Technical Data Notebook

Upper Rawhide Wash Floodplain Delineation Study (FCD 98-12)

Volume 1 of 4

Prepared for:
Flood Control District of Maricopa County

Cross Section for R030-1

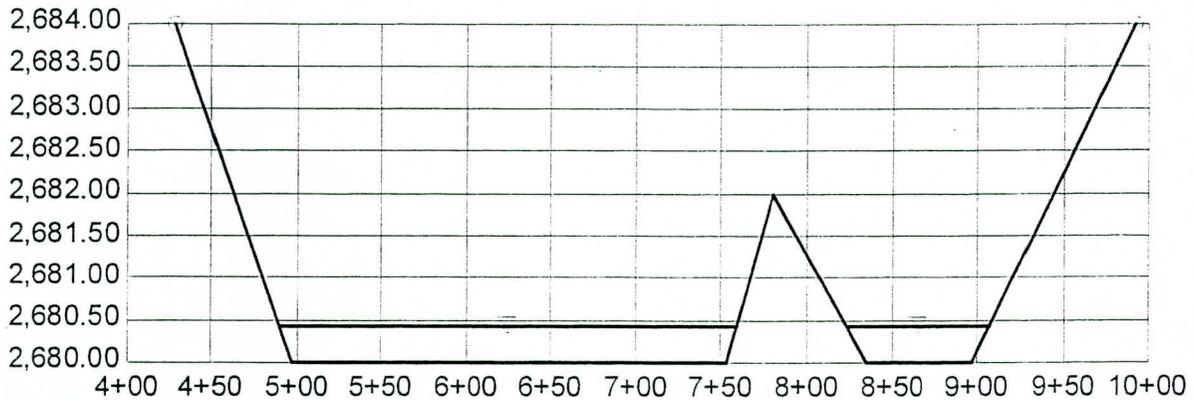
1. The velocity used to calculate the NSTPS for R030-1 is low compared to other subbasins with similar distance of travel. Hence the NSTPS value is quite high for this subbasin. A verification and explanation is needed.

Figure 5.5
Resistance Coefficient " K_b " as a Function of Watershed Size and Surface Roughness Characteristics

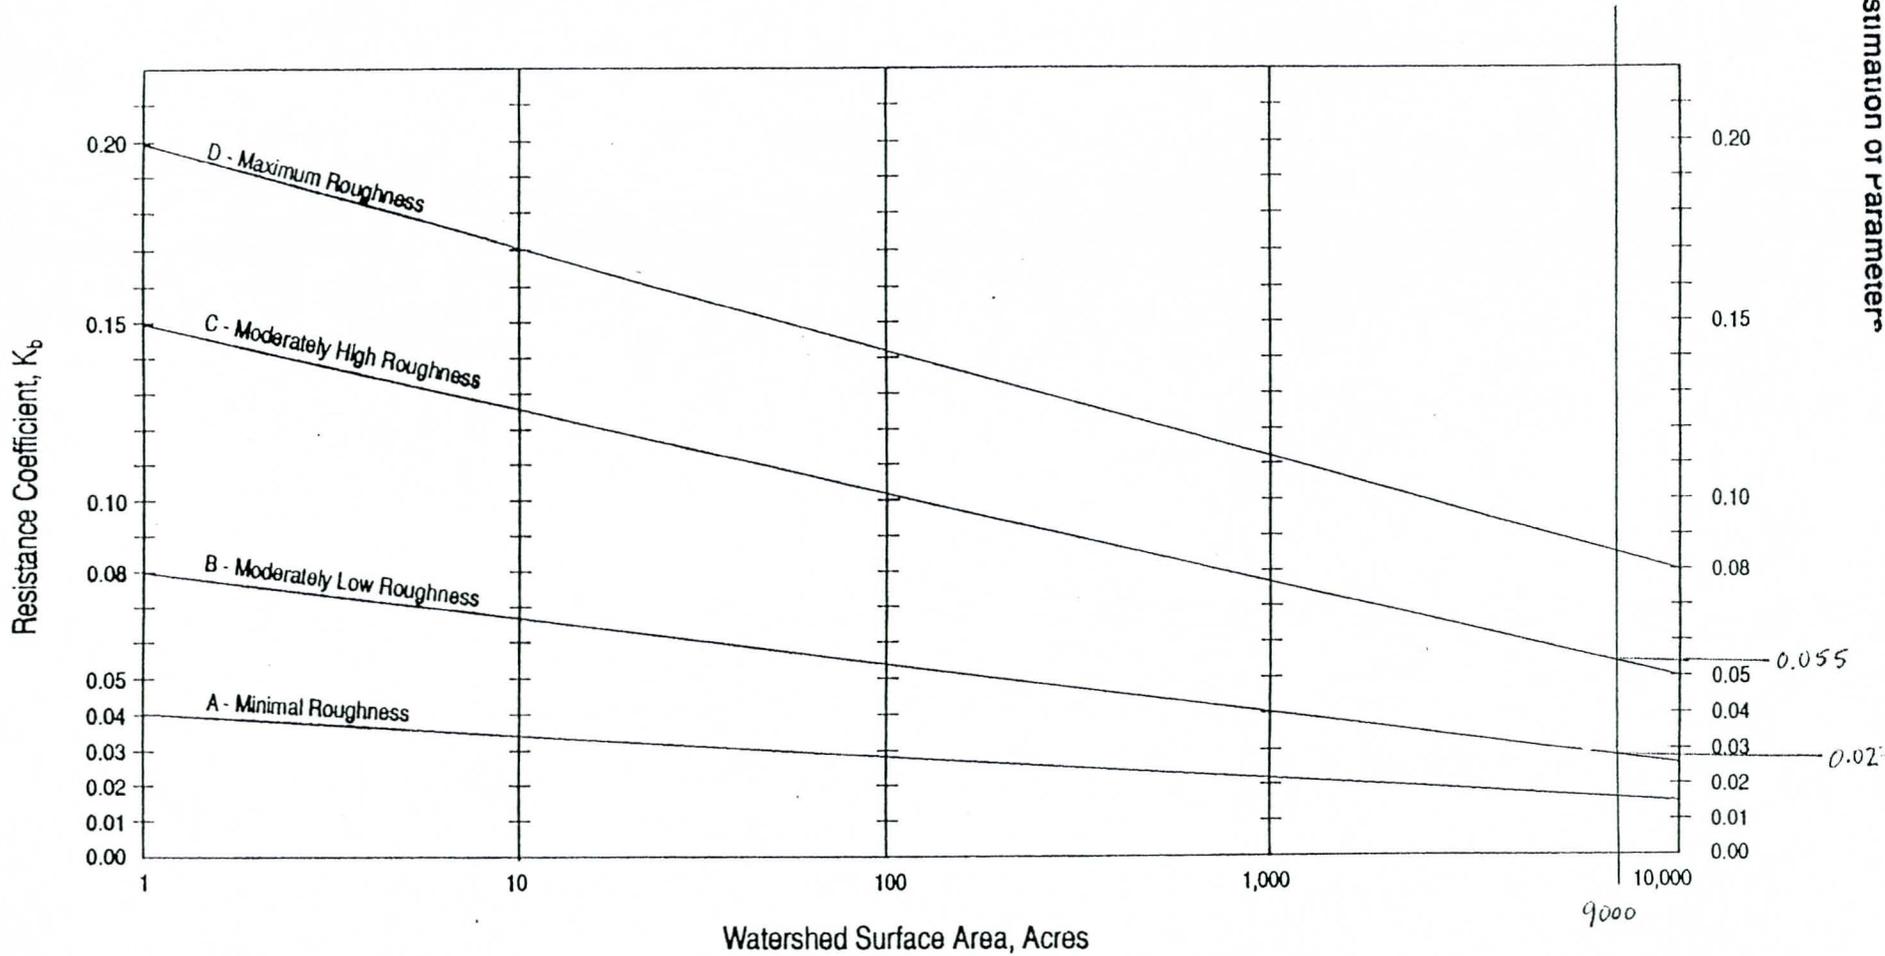
2. An explanation is needed as to the reason for choosing of the constant values m and b for the K_b calculations for applications that are related to type B of table 5.1 of the Drainage Design Manual, whereas the area is mainly of brushy alluvial fans, a type C classification.

Due to the dendritics of the watershed a somewhat faster response is anticipated. Moving to a Type C would lengthen the T_c , which would lower the discharge. This would appear to be inconsistent with meeting the concerns of the City of Scottsdale.

According to Figure 5.5 of the Drainage Design Manual, a watershed size of 9,000 acres such as this would have a K_b of 0.027 for Type B and 0.055 for Type C. See the attached table for the composite K_b values for each basin. The average K_b for our model using Type B is 0.049 (on the high end of that range) while the average if we had used Type C would be 0.094. Type B gives results consistent with Figure 5.5 for a watershed of this size..

Further, due to the subjectivity of the method, and results, a change is not warranted.
